# Service Bulletin

GL1800 #27  
Revised February 2024

## SAFETY RECALL

### 2020-2024 GL1800/B/BD/D/DA Fuel Pump Replacement

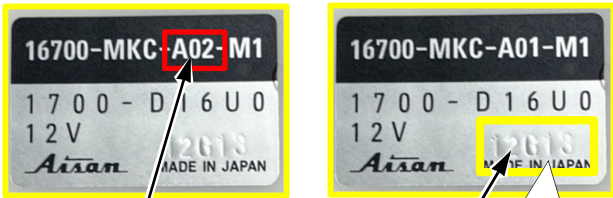
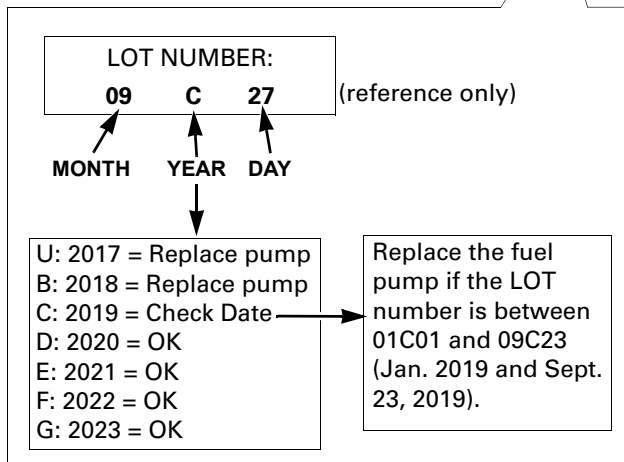
Inspect the identification label affixed to the top of the fuel pump.

1. Check the part number of the pump.

- For pumps with **-A01** in the part number, proceed to step 2 to check the LOT number.
- For pumps with **-A02** in the part number, the pump does not need to be replaced and no repair is required. Proceed to filing an "Inspection Only" warranty claim.

2. Check the LOT number located in the bottom right-hand corner of the label. If the LOT number shows a production date that is before September 27, 2019, the fuel pump must be replaced.
